UNITED STATES PATENT AND TRADEMARK OFFICE

APPLICATION NO.	FILING DATE	FIRST NAMED INVENTOR	ATTORNEY DOCKET NO.	CONFIRMATION NO.
10/727,096	12/02/2003	David K. Swanson	03-0242 (US01)	6001
23410	7590	11/14/2008		
Vista IP Law Group LLP 2040 MAIN STREET, 9TH FLOOR IRVINE, CA 92614			EXAMINER ROANE, AARON F	
			ART UNIT	PAPER NUMBER
			3769	
			MAIL DATE	DELIVERY MODE
			11/14/2008	PAPER

Office Action Summary	Application No. 10/727,096	Applicant(s) SWANSON, DAVID K.	
	Examiner Aaron Roane	Art Unit 3769

DETAILED ACTION

**Figure A**

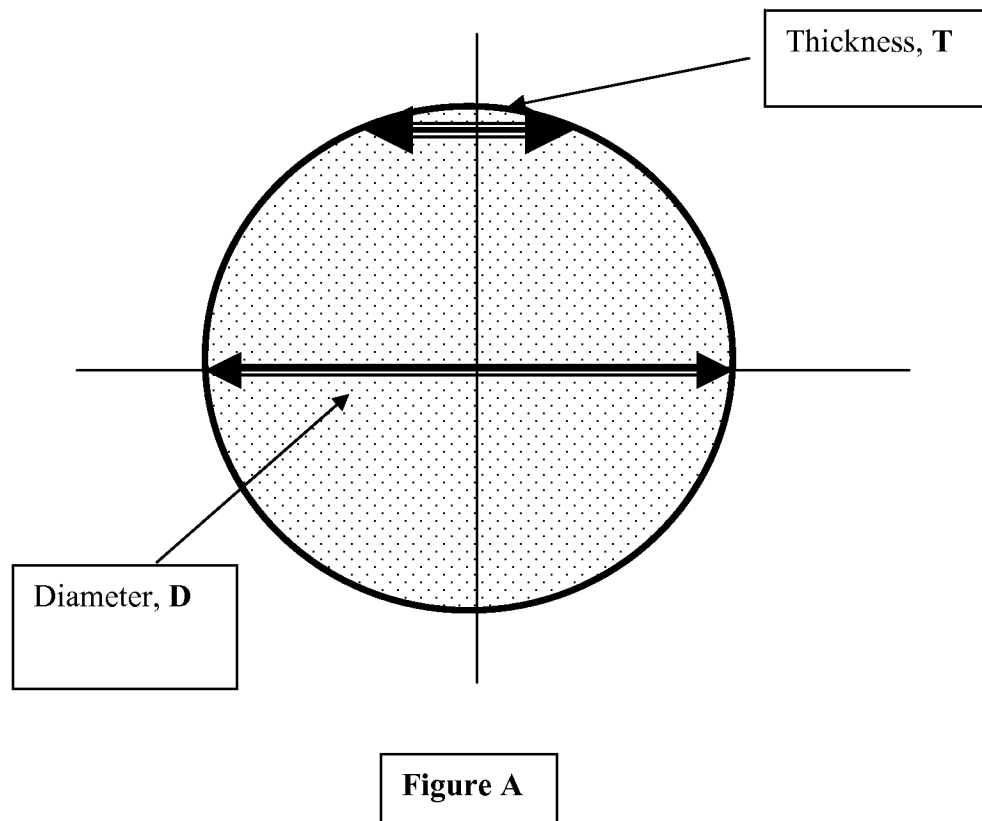
perimeter of about 1.5 mm to 3 mm, a thickness of about 0.01 mm and a diameter of about 0.5 mm to 1.0 mm. The examiner takes official notice of the perimeter as it is trivial to provide the annular electrically conductive member 13 (electrode) of Starver with perimeter of about 1.5 mm to 3 mm corresponding to the cross-sectional area of 13 and a thickness of about 0.01 mm in order to electrode with its full functioning capabilities. It should be further noted that a circular perimeter of 1.5 mm to 3 mm yields a diameter of about 0.5 mm to 1 mm. As Applicant has traversed the official notice rejection, the examiner now provides a prior art reference which has been cited only to support the previous official notice rejection (see MPEP 2144.03(a-d), particularly 2144.03(d)). Specifically it is the cross-section of the electrode that is relevant for this rejection. Starver discloses an annular electrode (20) which is circular, see figure 7. Ostroff et al. (7,149,575) disclose an electrical tissue stimulating device and provide an electrode having a circular cross-section with diameter of 1-5 mm, see col. 5:351-67 and figure 1. Since the perimeter, **P**, of the electrode cross-section is given by

where **D** is the diameter and **r** is the radius. Therefore, in order for the perimeter, **P**, to be about 1.5 mm to 3 mm, the diameter, **D**, must be about 0.47mm to 0.95mm. Since 1mm is about 0.95mm (a difference of less than 5.3%), the perimeter and diameter recitations have been met. Regarding the thickness of about 0.01mm, it can easily be seen from the **figure A** below, given a circular cross-section, a thickness can be defined which the circular cross-section inherently has and that is about 0.01mm. Figure A depicts the electrode's circular cross-section having a diameter, **D** and thickness, **T**. It should be

noted that thickness of 0.01mm is located almost at the top of the cross-section and for further illustration it should be noted the distance from the center of the circular cross-section to where the thickness is 0.01mm is equal to the square root of $(0.5\text{mm})^2$ minus $(0.005\text{mm})^2$.

Finally, Applicant may argue Starver doesn't disclose a circular cross-section. The examiner counters with the fact that a portion of the cross-section is circular (the upper portion) and it is that portion that defines (in view of the official notice and Ostroff et al. (7,149,575)) the recited dimensions.
